**RE: Response to Back River Project Type A Water Licence Technical Comments (2AM-BRP----**

The **BACK RIVER**  
**PROJECT**

**TYPE A WATER LICENCE  
TECHNICAL COMMENT RESPONSES**

April 2018  
NWB File No. 2AM-BRP----

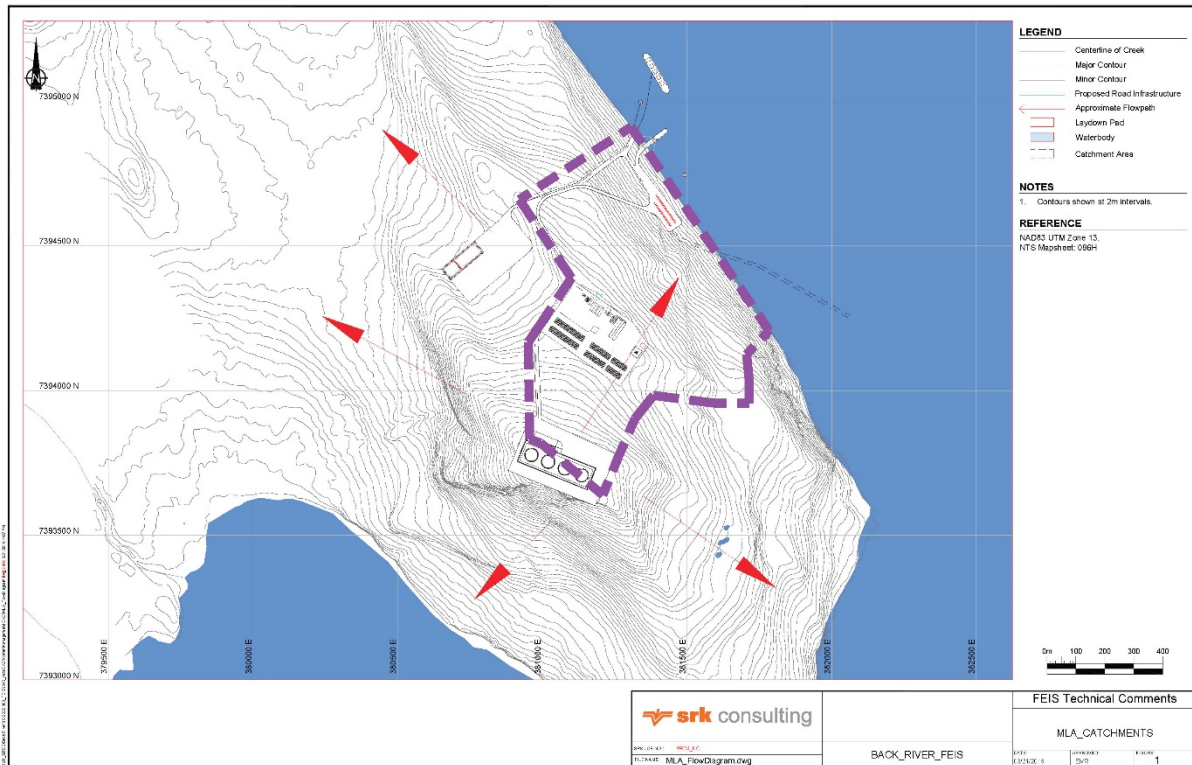
Sabina should provide the source inputs for water quality predictions in the MLA, and a discussion as to why certain parameters such as arsenic are elevated above both baseline concentrations and the CCME marine WQO.

Sabina should also outline appropriate management options that will be implemented to mitigate the impact.

In order to understand the effect of constituent loading from contact water (i.e., from road and rock pads constructed from geochemically suitable sources at the MLA), a water and load balance model was prepared to estimate dilution capacity at MLA. Predictions are based on a ratio of undisturbed and disturbed catchments. The model examines the catchment area with the highest ratio impacted area to unimpacted catchment areas. Water quality predictions would be better for catchment areas with a lower ratio of impacted to unimpacted catchment areas. Figure 1 shows the approximate flow paths from the rock pads, and the delineation of the catchment area with the highest ratio of impacted

Aquatic Life. Though it is not expected that all runoff from the catchment in Figure 1 will fully mix prior to entering the Bathurst Inlet, this example shows how much, if any, additional dilution is required from the Bathurst Inlet to meet the CCME marine life water quality guidelines.

Figure A-11: General Arrangement Sheet 1 of 2

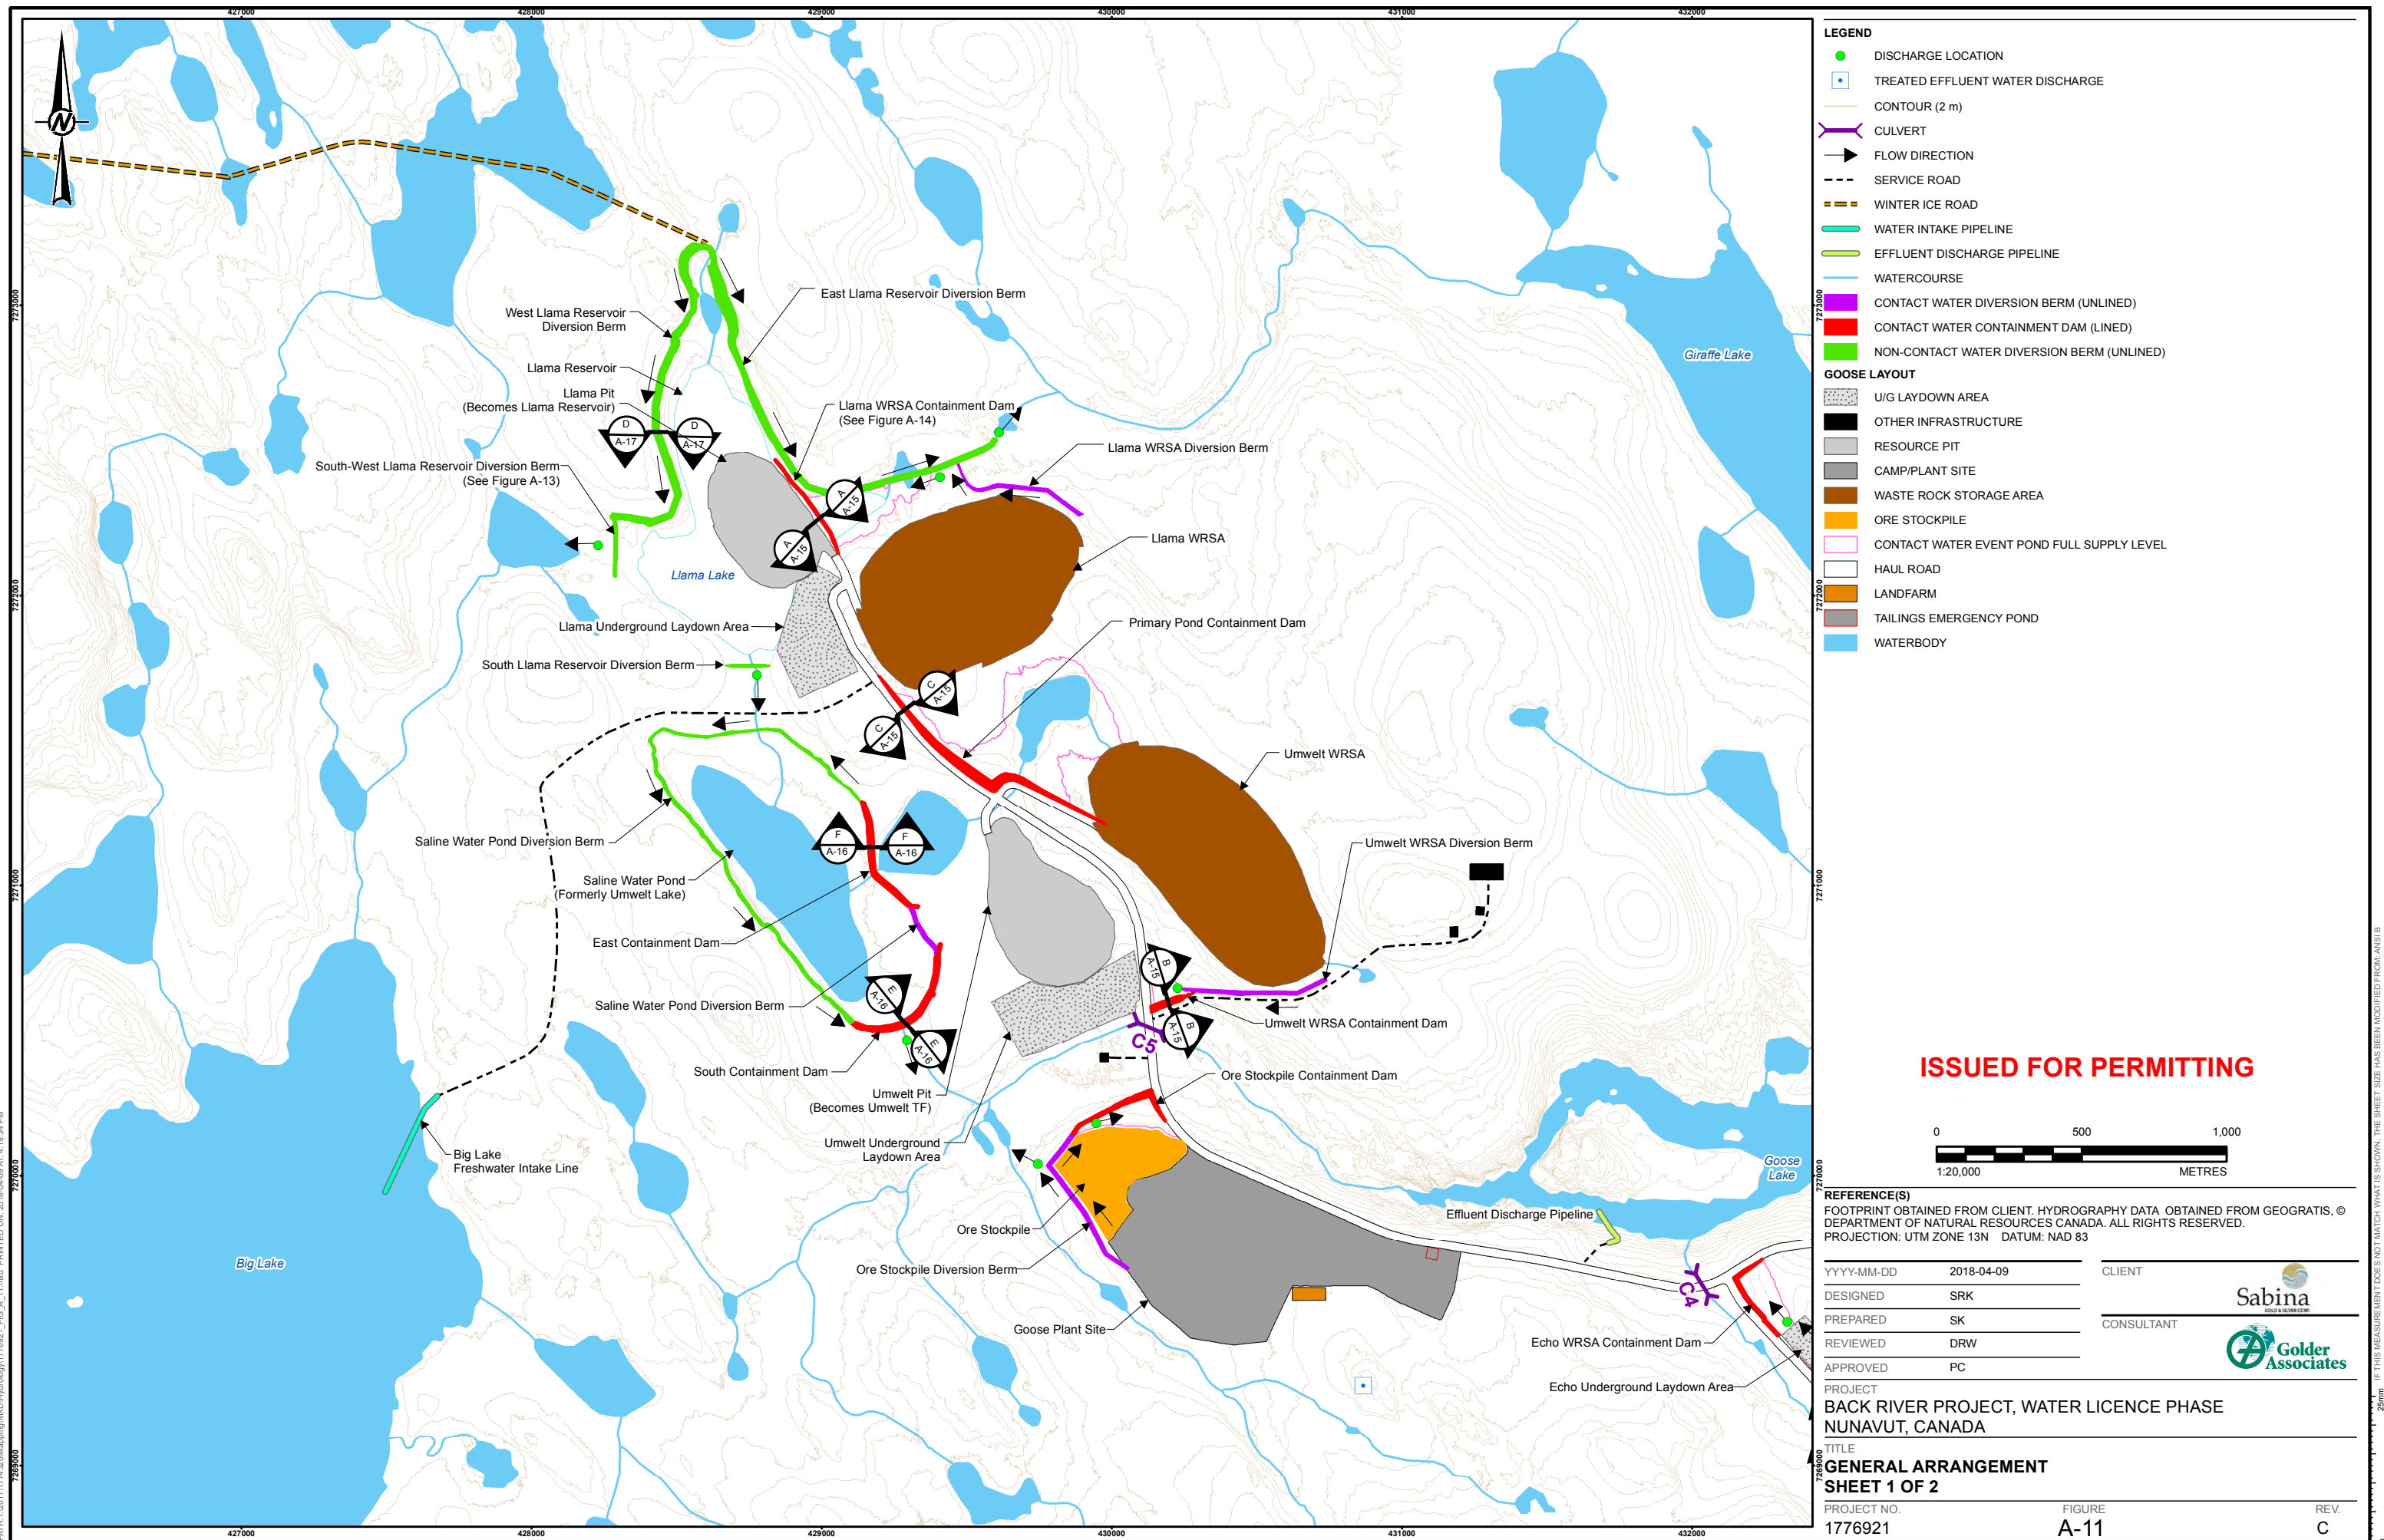
The discharge location shown on updated Figure A-11 for Umwelt WRSA Diversion Berm appears to flow into the Umwelt WRSA. This is possibly in error since the purpose of the berm is understood to be to prevent the inflow of runoff into the WRSA from the upper basin area.

Sabina acknowledges CIRNA's request and has provided updated versions of Figure A-11 and Figure A-12 of the Water Management Plan (171002 2AM-BRP----SD05-WaterMgmtPlan\_IMLE) with the noted changes.

Figure A-12: General Arrangement Sheet 2 of 2

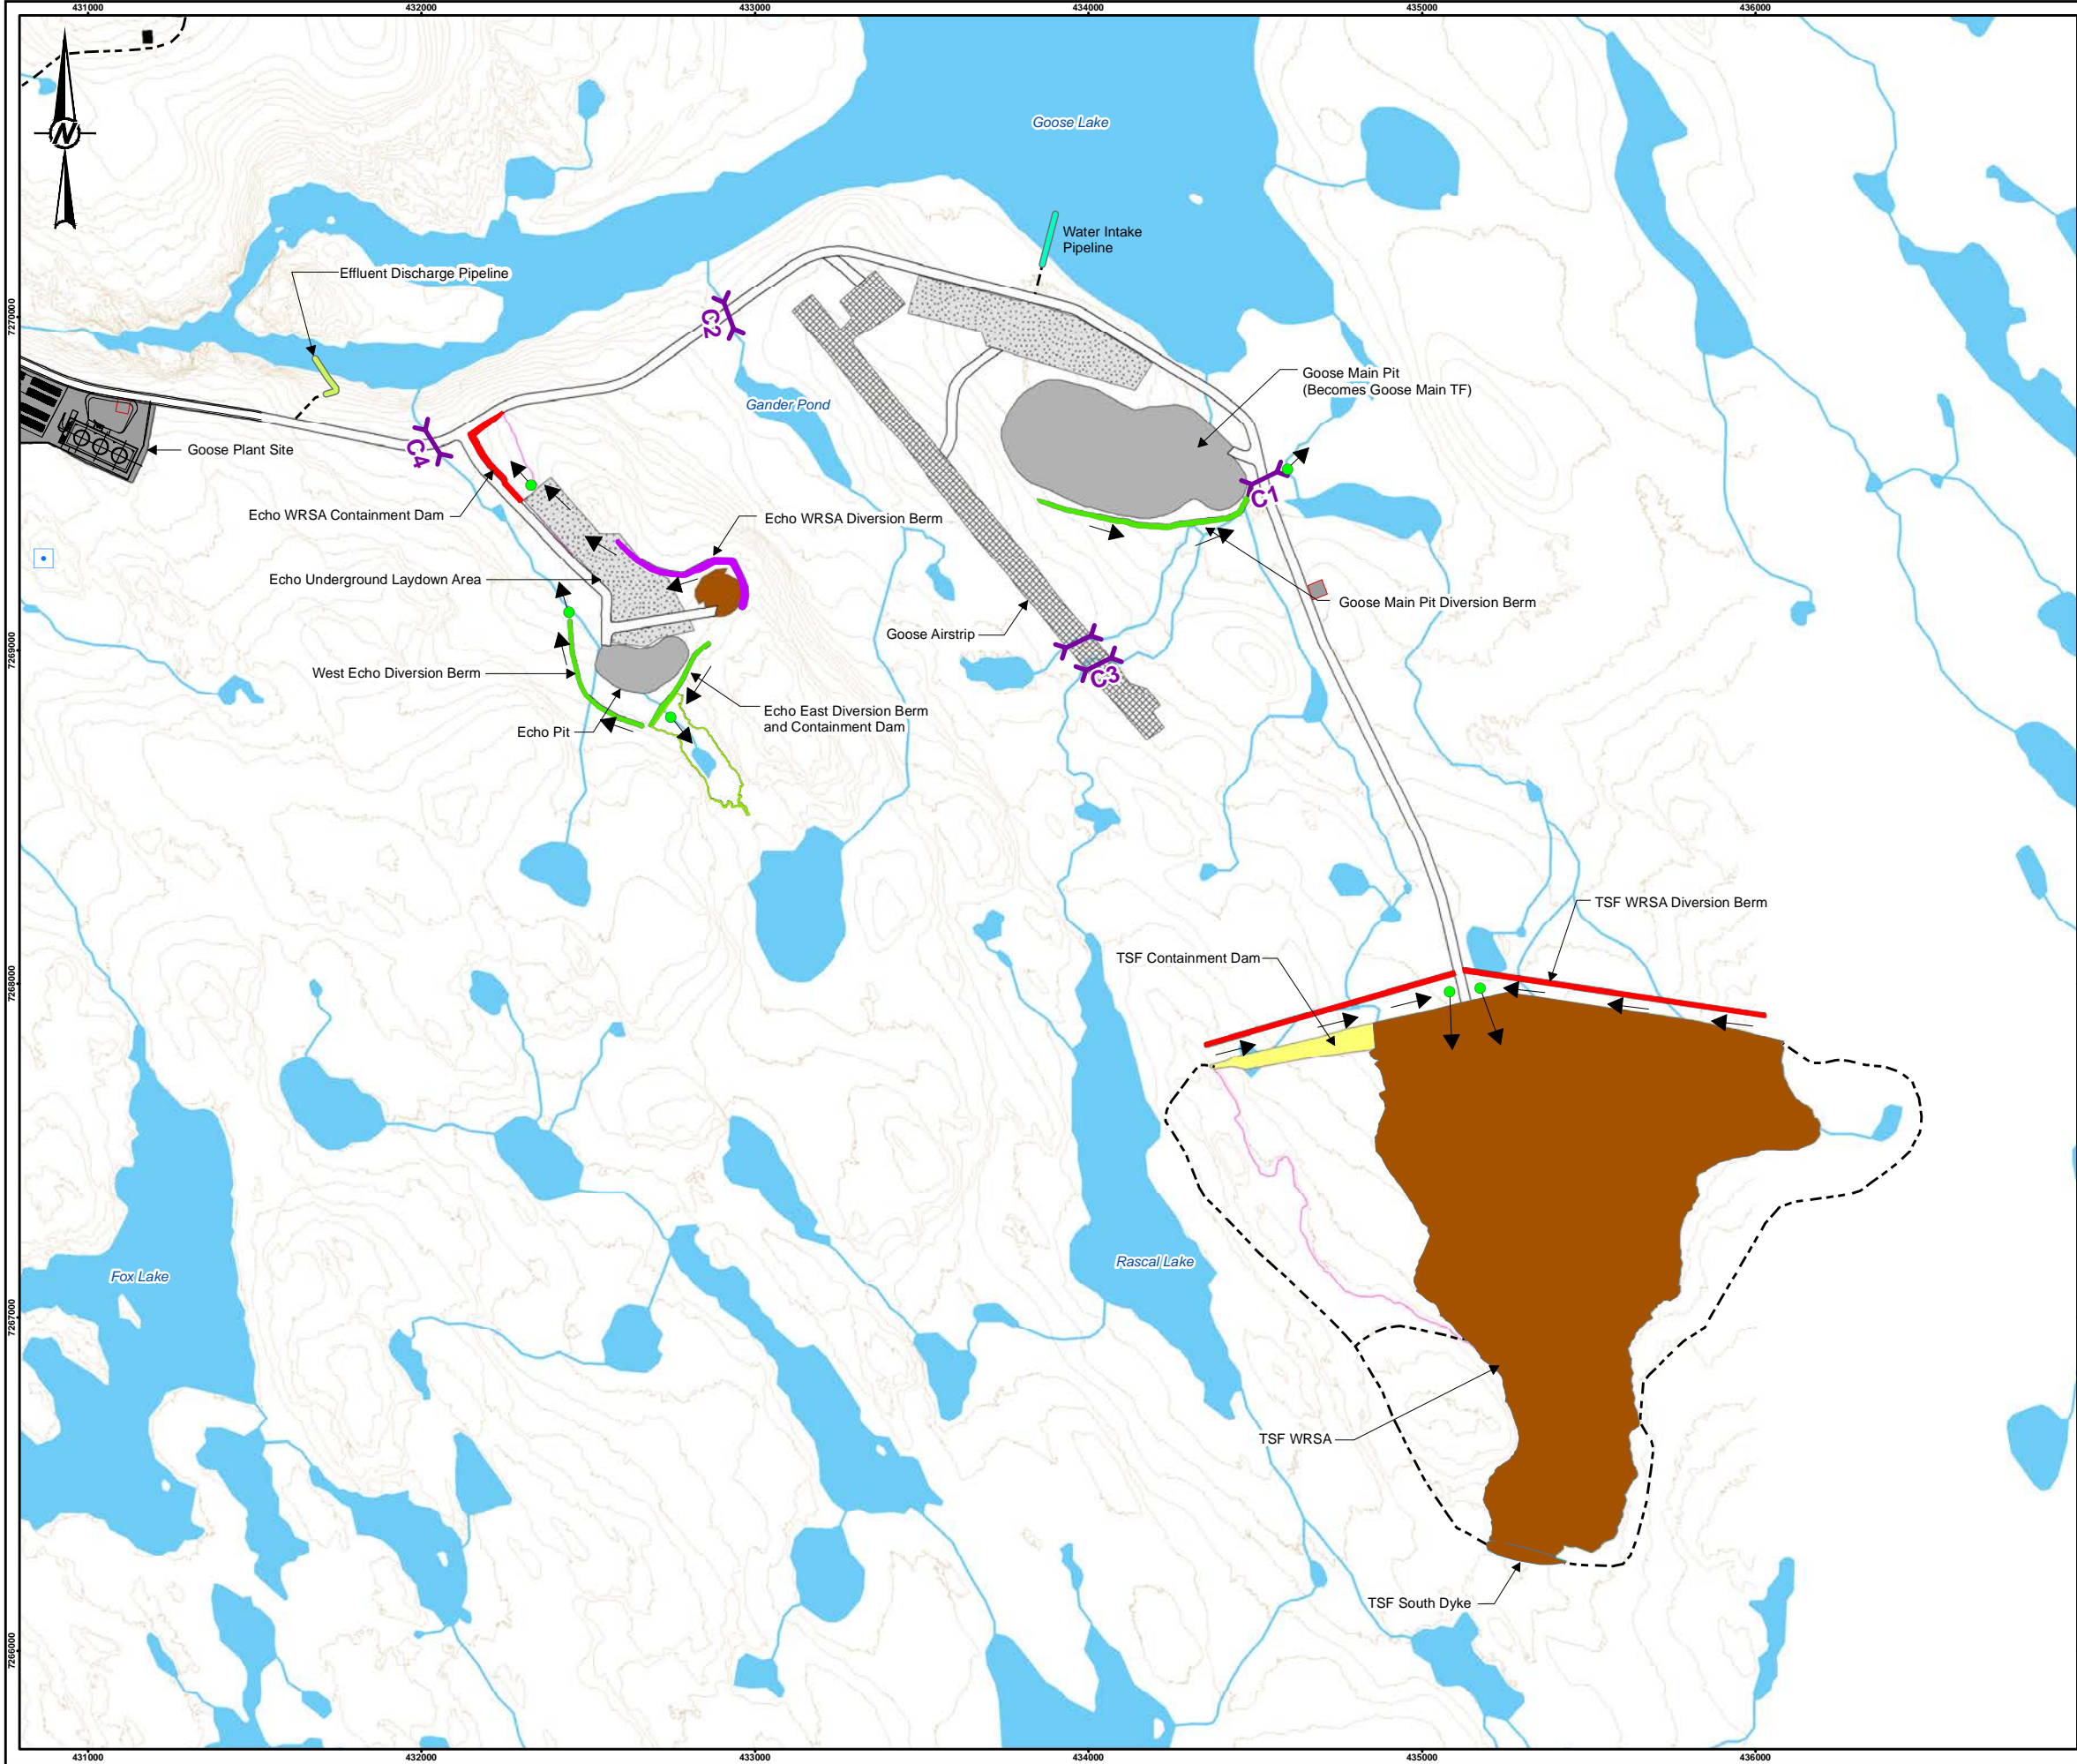
Updated Figure A-12 does not show flow directions or discharge location for the TSF WRSA Diversion Berm.

The figures that follow, A-05 (Phase 2 Stage 2) through A-08 (Phase 4 Post-Closure) and Figure A-12 all show an altered footprint of waste rock storage that extends over the top of approximately  $\frac{3}{4}$  of the longitudinal extent of the Phase 1 containment dam. This configuration suggests that much of the original dam will be covered with tailings and will not provide its original water management function after the Phase 2 Stage 1 operations have concluded.

Sabina clarifies that the figures referenced above (Figure A-05 to Figure A-08, and Figure A-12) shows that only waste rock will be placed over the crest of the TSF Containment Dam. The waste rock is shown in brown in Figures A-05, A-06, A-12, and shown in grey in Figures A-07 and A-08. Sabina apologies for any confusion; please refer to Figure A-02 and Figure A-09 of the Tailings Management Plan (171002 2AM-BRP---SD09-TailingsMgmtPlan-IMLE) for further details on the relative placement of tailings and waste rock associated with the TSF.
